### Service information

Reference no.: GDA\_113045

Piston changes color (in the brew unit) for Minuto platform.

Image 1

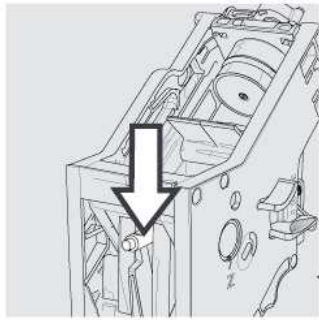
From s.n. TW901615221079 changes the color of the piston of the brew unit from black to gray (Image 1) making it more recognizable from consumers to perform lubrication, as explained in DFU (Image2). The new code is **421944065811** GRY BREW UNIT 8GR.INT.PISTON GEN.V3 ASSY.

Image2

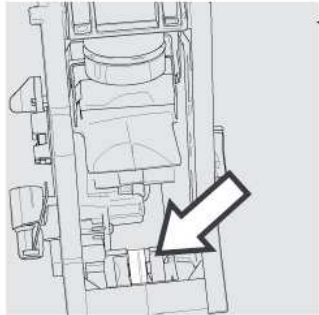
Also lubricate the shaft
